PLANNING APPLICATION

<i>Description of proposal:</i>	Ross public amenities - replacement of existing (heritage-listed place in heritage precinct)
<i>Site address:</i>	12 BRIDGE STREET (CNR CHURCH ST), ROSS
<i>CT:</i>	122337/1
<i>Estimated cost of project (include cost of landscaping, car parks etc for commercial / industrial uses)</i>	\$150,000
<i>Are there any existing buildings on this property?</i>	Yes
<i>If yes – use of main building:</i>	Town Hall and Public Amenities

Re: New Toilet Block in Ross
Planning Application Ref No: P15-235

REPORT FROM: HERITAGE ADVISER, TONY PURSE
DATE: 02-Oct-2015
REF NO: P15-235; 400500.18
SITE: 12 Bridge Street (cnr Church St), Ross
PROPOSAL: Ross public amenities (replacement of existing)
- vary side and rear setbacks to 1.5m (heritage-listed place in heritage precinct)
APPLICANT: Northern Midlands Council
REASON FOR REFERRAL: HERITAGE PRECINCT
HERITAGE-LISTED PLACE
Local Historic Heritage Code
Heritage Precincts Specific Area Plan

floor plan
Scale: 1:100

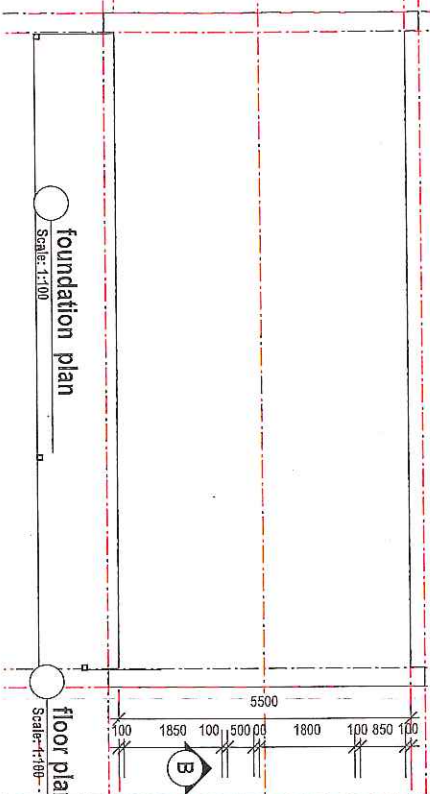
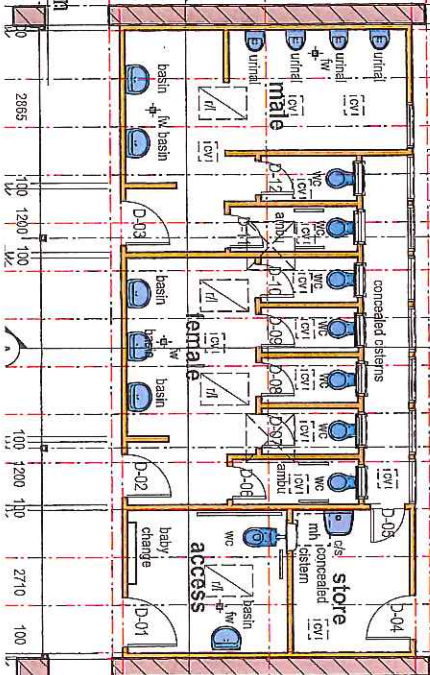
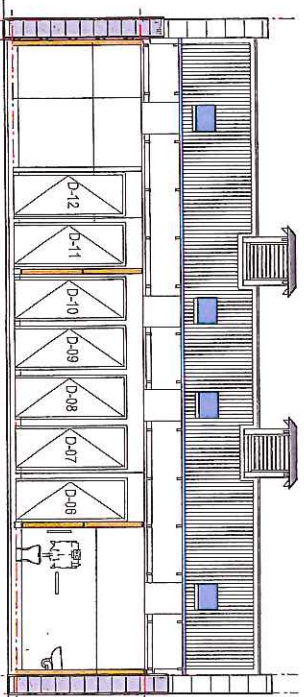
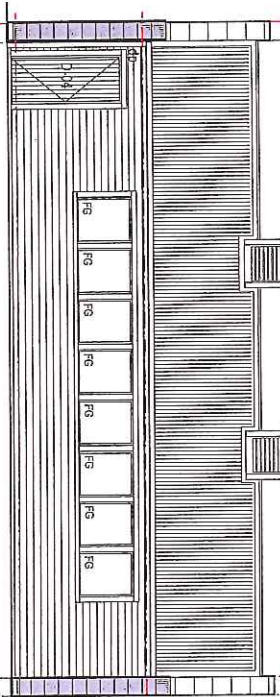
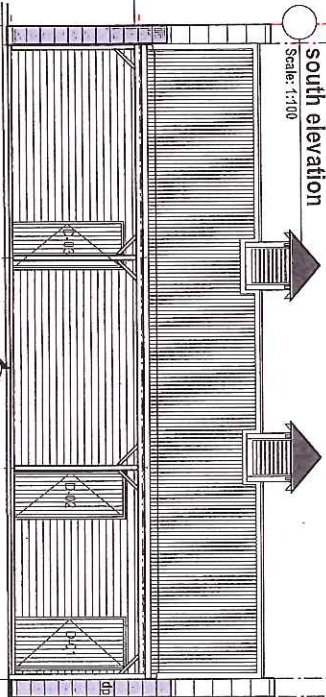
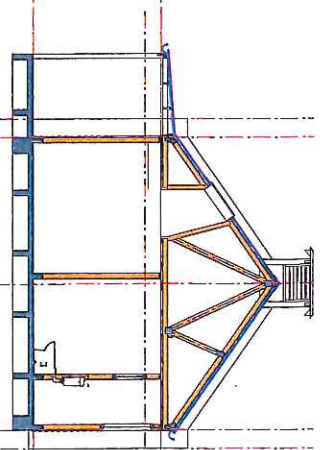
We noticed that the artist's impression differs from the plan in two features:

Firstly, the pathway structure on the Church Street end is not shown in the plan. Without proper explanation of this, we cannot be certain that it will be a good improvement on the design. This addition may not be needed.

Secondly, the square section at the top of each end wall is not shown in the plan. This could be an improvement on the design in the plan, but it needs to be shown in the plan, especially so that the dimensions are made complementary with the design. It would be good to identify an example of this detail being used in a colonial era building, if it is to be included and that it is not a feature from a later period of history.

1. The pathway entrance structure has been added to the plan and elevations.
This element is a contemporary interpretation of a colonnade that was traditionally used to direct pedestrian movement within open spaces.
I decided to include this in the design due to the considerable setback of the building from the Church street.
It will help define the entrance to the toilets when entering from Church Street.
It is a very minimalist structure that in my opinion will not have an adverse impact on the historic character of the place.
I have also shown the existing and recommended paving and planting on the site plan.

2. I have amended the plan and elevations to show the square top gables as per the 3D image.
This is a traditional detail that was used in early colonial (modest) cottages and utility structures.
I have attached a couple of photos of a early 19th century cottage in Northern Tasmania with this detail.

SITE PLAN
 SCALE 1 : 500 @ A3

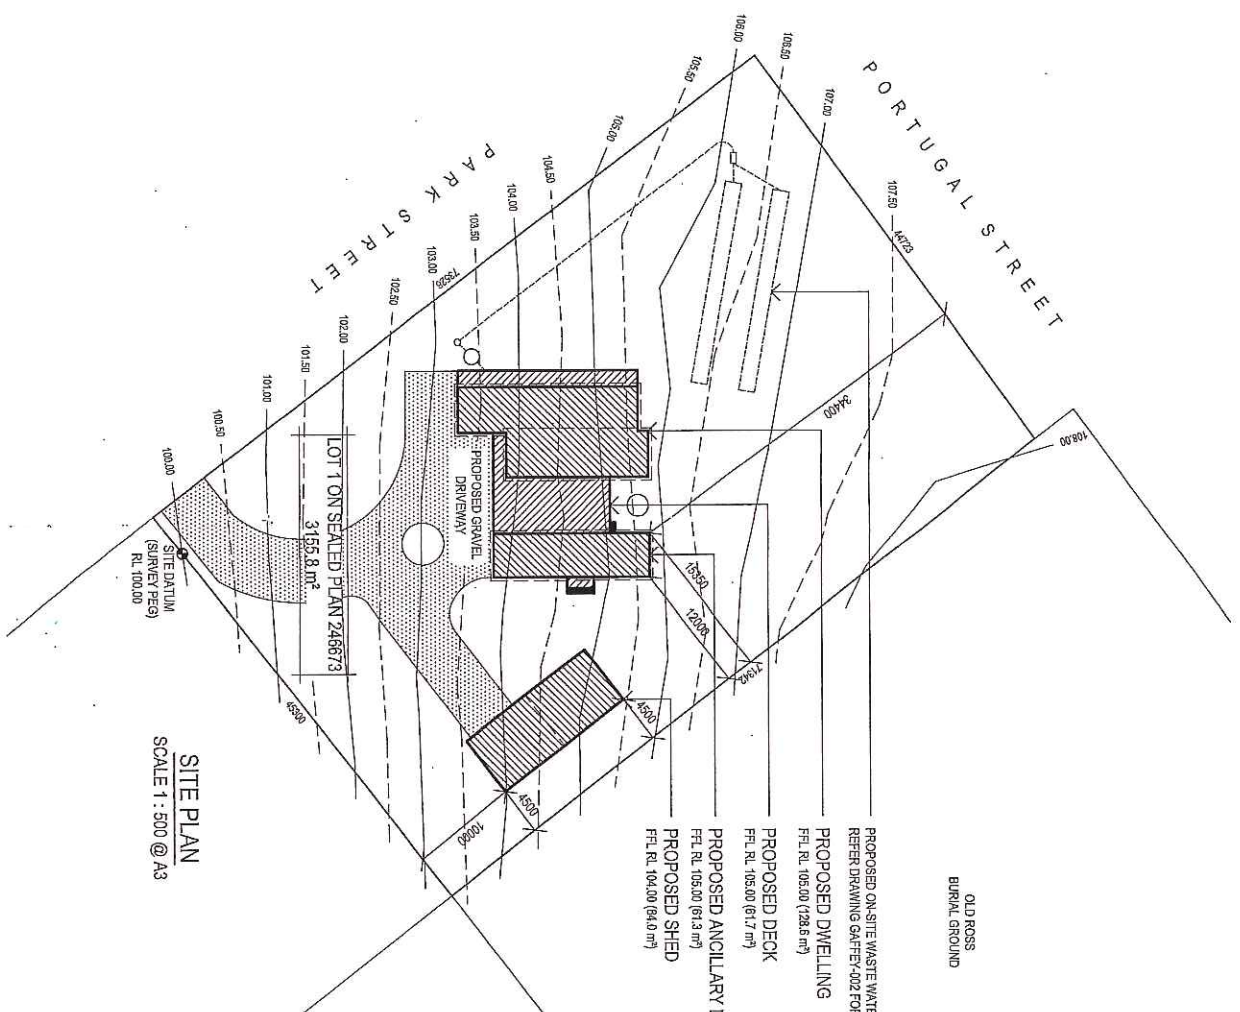
The northern boundary of the site plan is depicted as a street (Portugal Street), which it is not. It is a two meter wide public walkway, a section of the Ross Historic Walk (See Figure 2.). The depiction in the planning application is misleading at best and dishonest at worst.
